## HISTORIC AND DESIGN REVIEW COMMISSION

**2018-207**

410 N OLIVE ST

New Construction - Conceptual

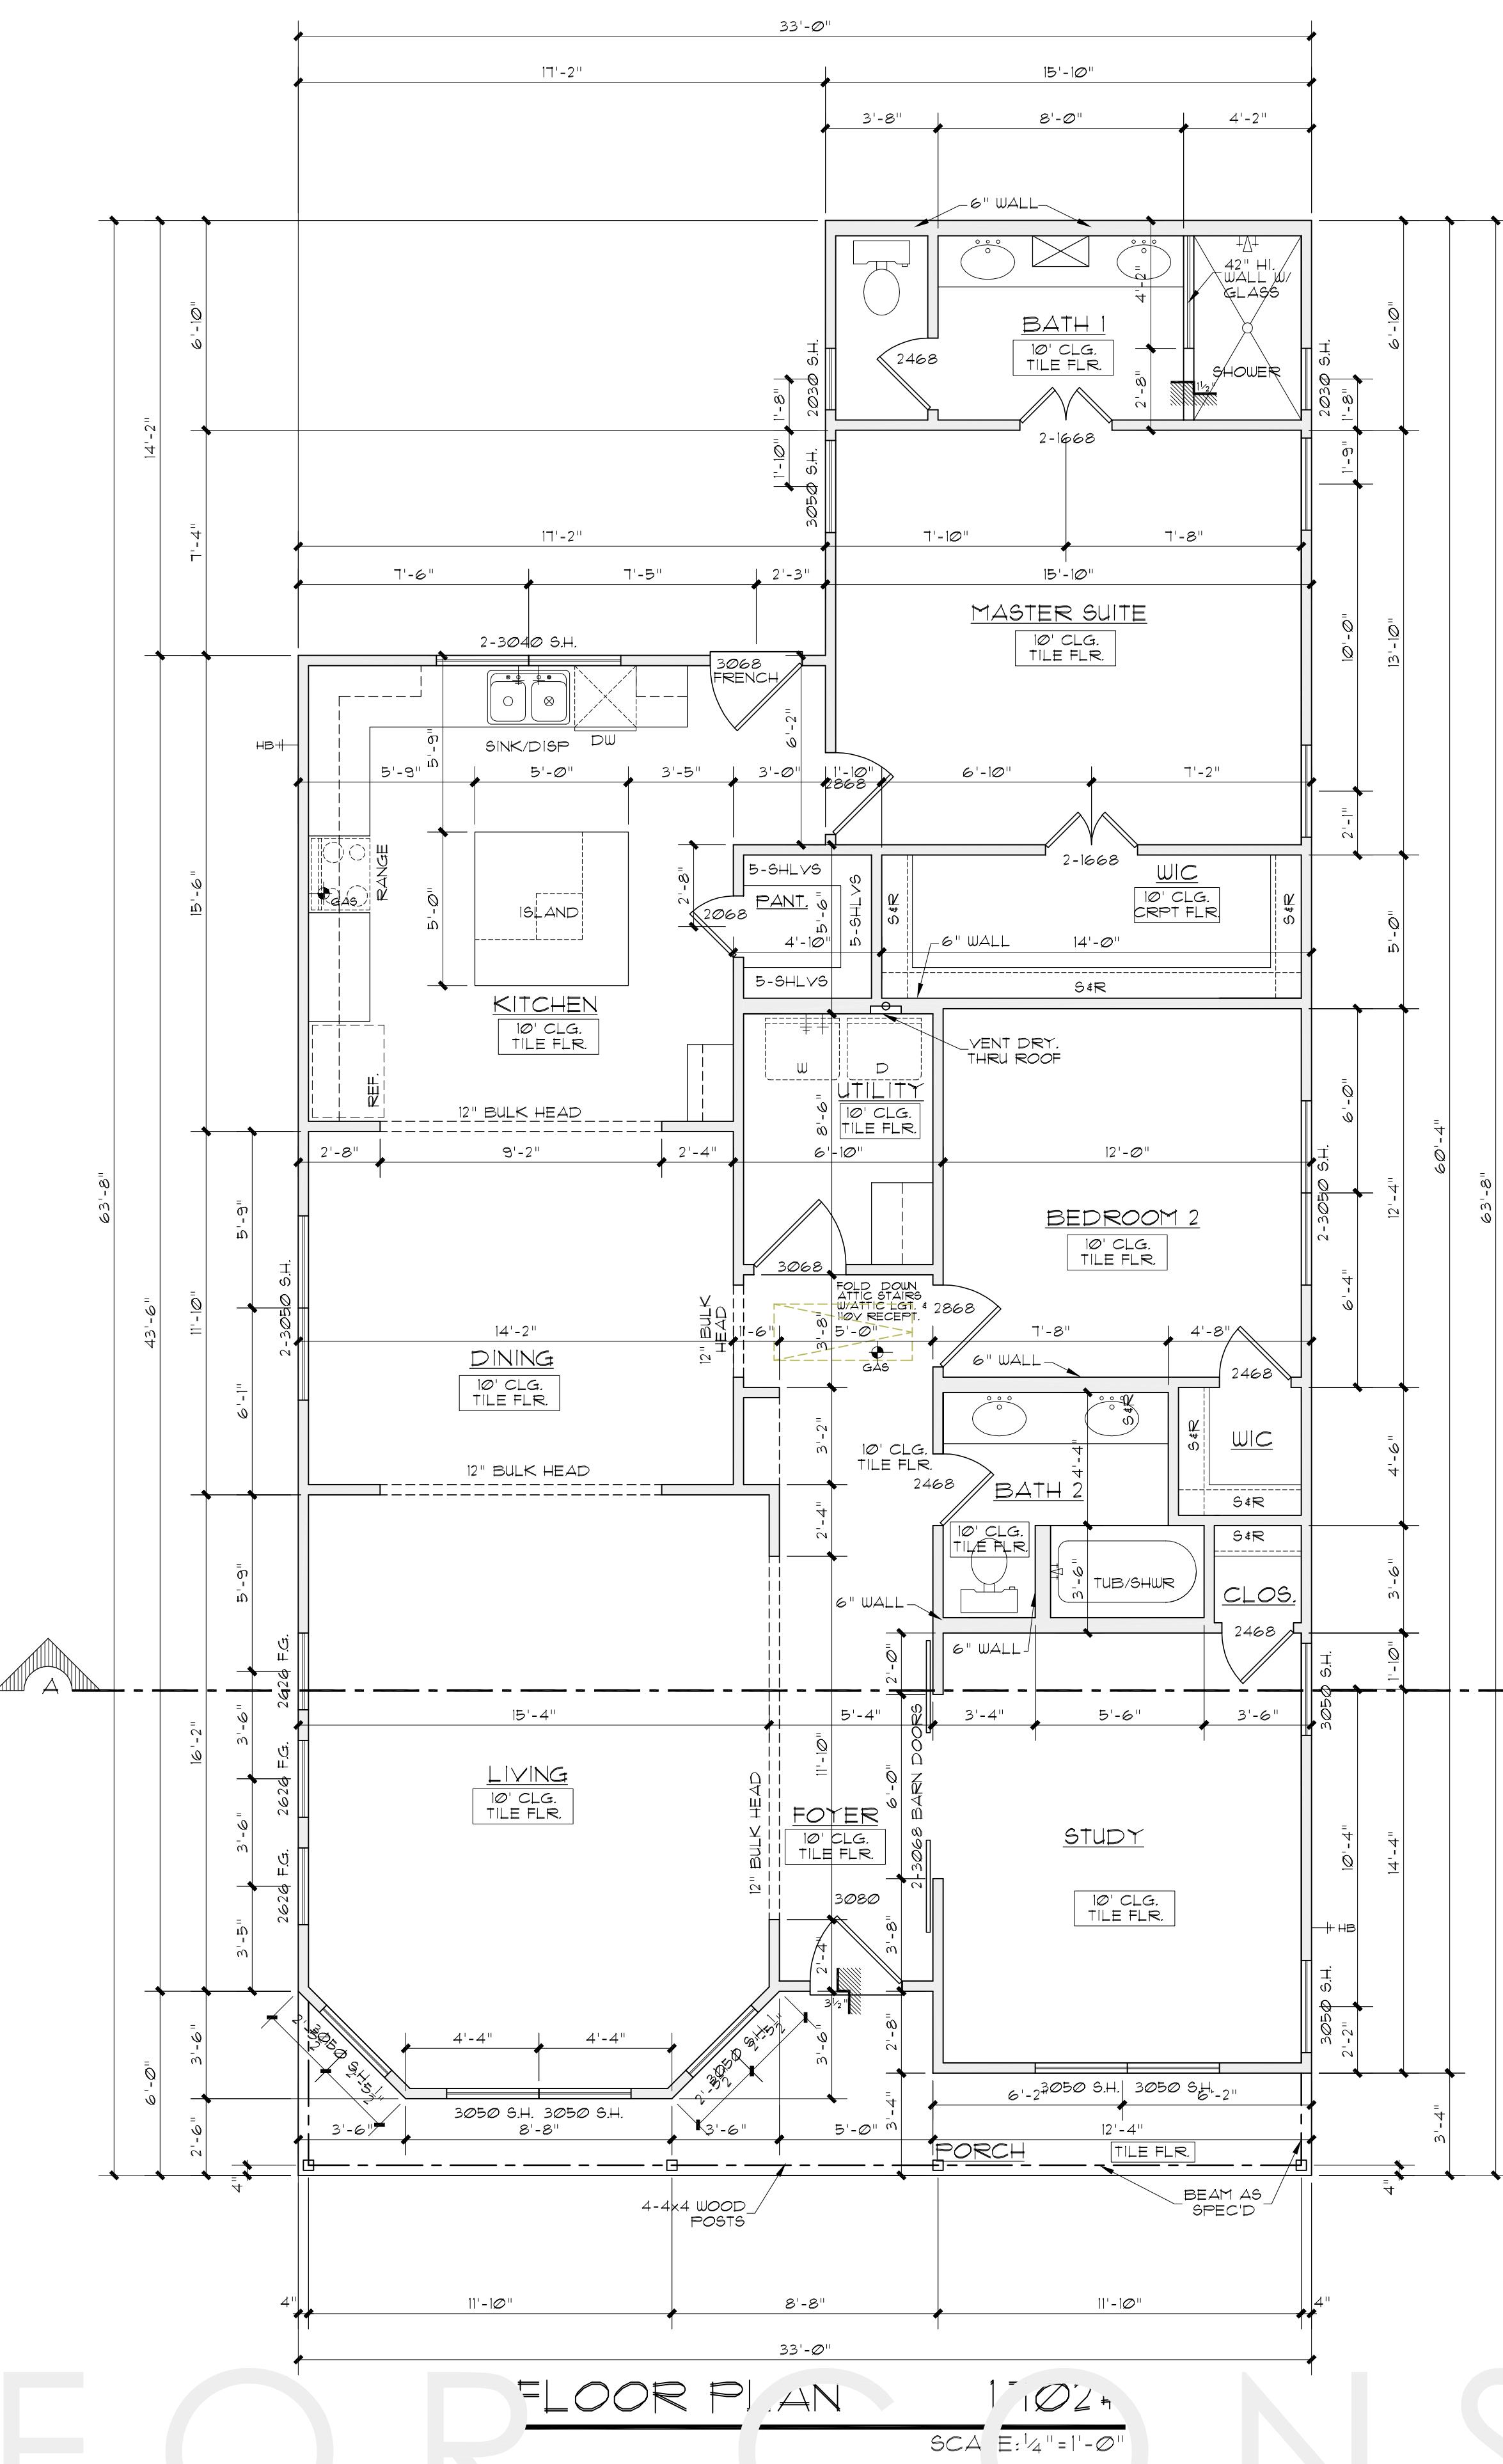
- n. DRIVEWAY – The applicant has proposed to install a driveway that will lead into the front façade of the proposed new construction, resulting in a driveway that is the depth of the front yard as well as front yard parking.

The Guidelines for Site Elements 5.A. notes that the historic pattern of driveways found in the district should be followed. Additionally, The Guidelines for Site Elements 7.A. notes that off street parking is to be located at the rear or side of the primary structure. The proposed driveway and parking locations are not consistent with the Guidelines.

- viii. That the proposed driveway and front yard parking locations be eliminated as noted in finding n.

FRONT ELEVATION

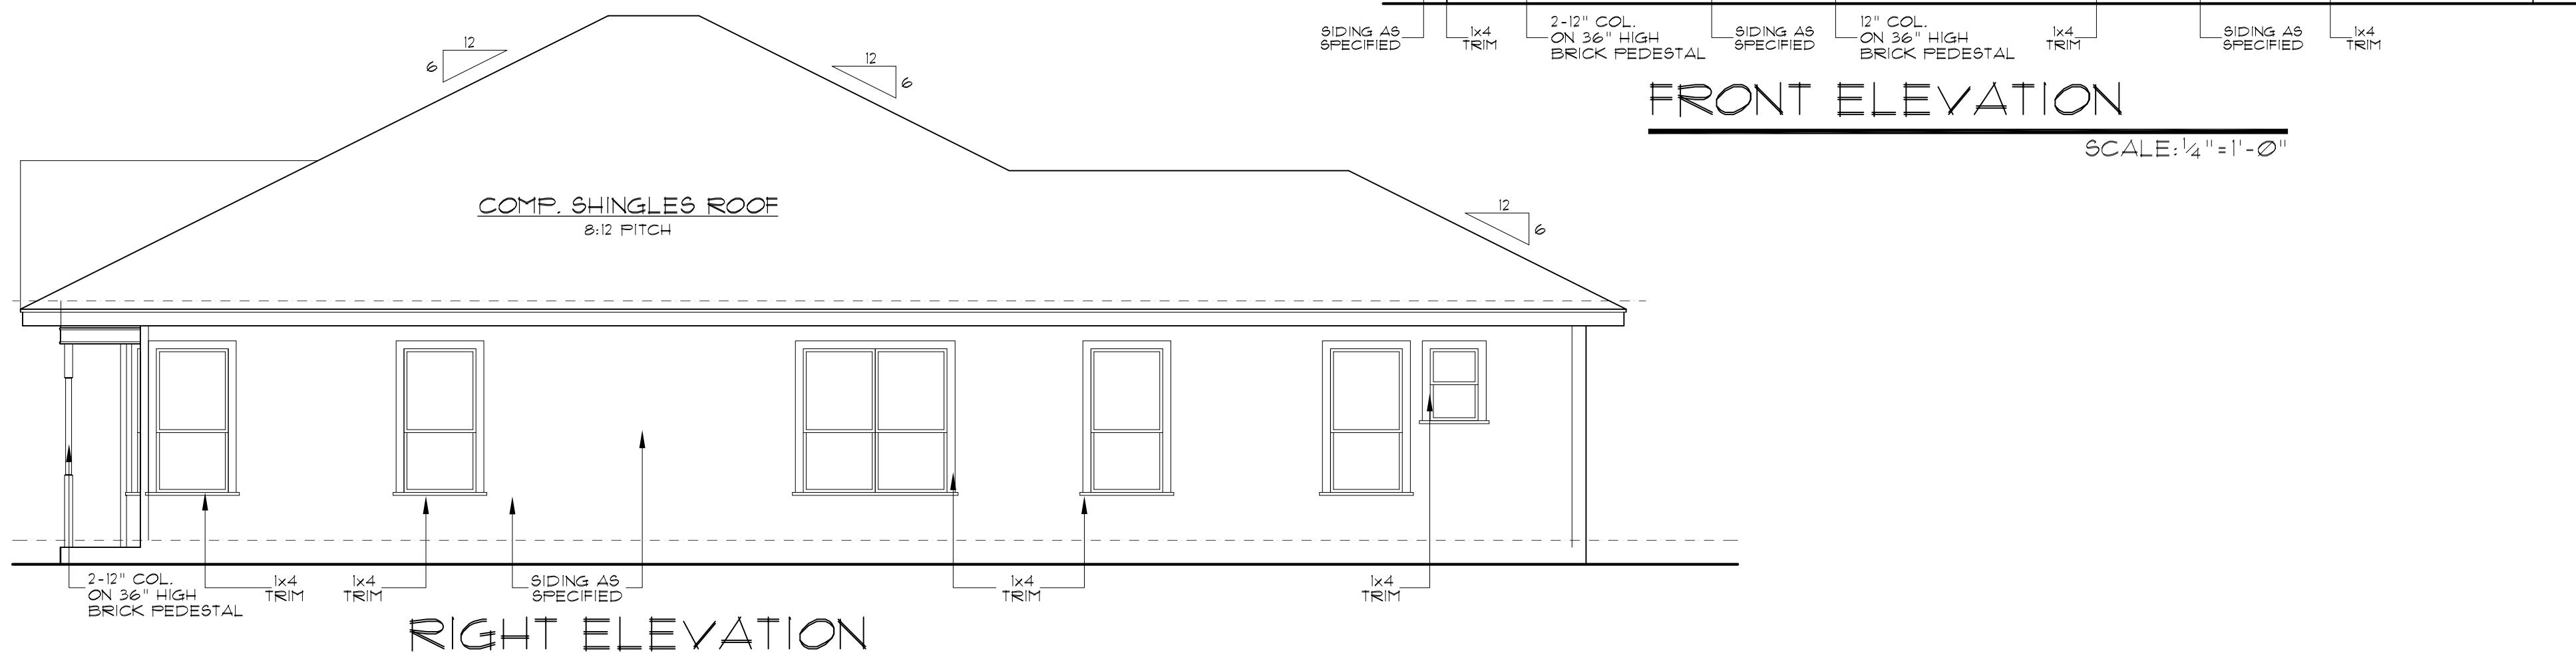
- i. WINDOW BAY (Fenestration) – The applicant has proposed a window bay to feature a total of four windows. Double windows will be featured at the center of the bay, a detail that is not found historically throughout the Dignowity Hill Historic District. Staff finds that a single window, centered under the gable should be installed.

- j. FRONT FAÇADE MASSING – The applicant has proposed front façade massing that includes a window bay that is covered by a gabled roof which features the same façade plane as the structure's primary roof (hipped). The historic profile of a window bay includes an extension beyond the profile and massing of the structure's primary roof and porch. Staff finds that the primary wall of the structure should be shifted toward the rear to produce a true “L-plan”, rather than feature a window bay that shares a wall plane with both the porch and front façade of the house.

- iv. That the proposed window bay feature three windows with the middle window being centered under the gable as noted in finding i.
- v. That the primary entrance wall of the structure should be shifted toward the rear to produce a true “L-plan” with a protruding front bay rather than a window bay that shares a wall plane with both the porch and front façade of the house as noted in finding j.
